Date Request Received: April 16, 2025 Data Request No. DOE 1-001 Date of Response: May 02, 2025 Page 1 of 3

For each U199 pole structure in the town of Bethlehem:

Please explain in detail how the proposed U-199 project addresses each of the issues/factors identified on page 18 of the Commission's March 3, 3025 order in Docket No. DE 24-087.

E\		ERS				
					TITLE							
					BY	JJD	CHKD	CRP	APP	KJD	APP	
					DATE	12/15/21	DATE	12/15/21	DATE	12/15/21	DATE	
					H-SCALE	AS SHOWN	SIZE	D	FIELD	BOOK & PAGES		
NSTRUCTION 1U01	JJD	KJD	KJD		V-SCALE		V.S.		R.E. D			
VISIONS	BY	СНК	APP	APP	R.E. PROJ	. NUMBER			DWGN	••• 040	<u>91-40002</u>

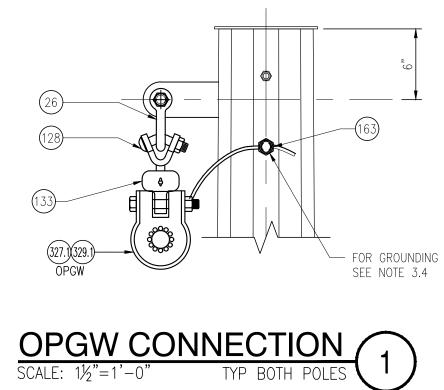
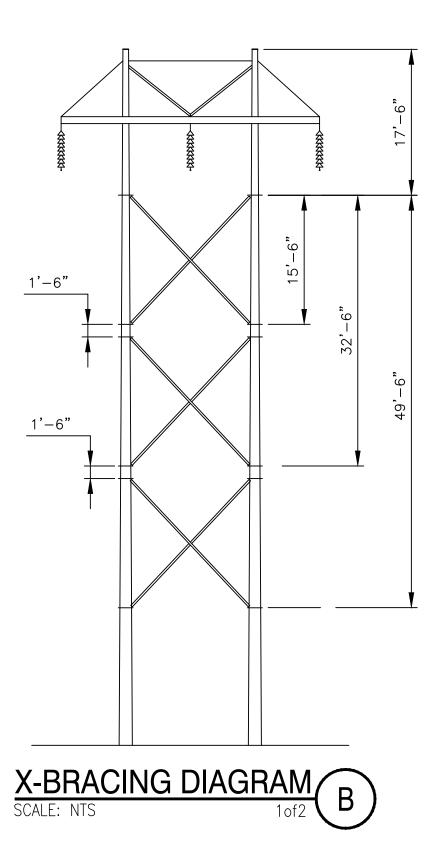
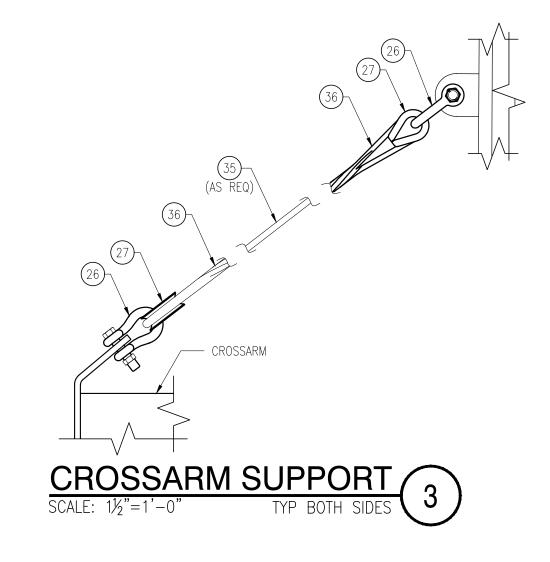
- ii. If no replacement designs meet the 40ft height restriction, what are the limiting factors?
- c. Please provide representative design diagrams and/or pictures of the recommended replacement structure solution, e.g., H-frame, single-pole.

- c. See Attachment DOE 1-001, Eversource standard H-Frame transmission structure.
  - i. Weathering steel structures will be used for the five replacement structures.

- The majority of the line will be direct embed poles set in a corrugated steel casing (sleeve) with no foundations, including all of the structures in Bethlehem.
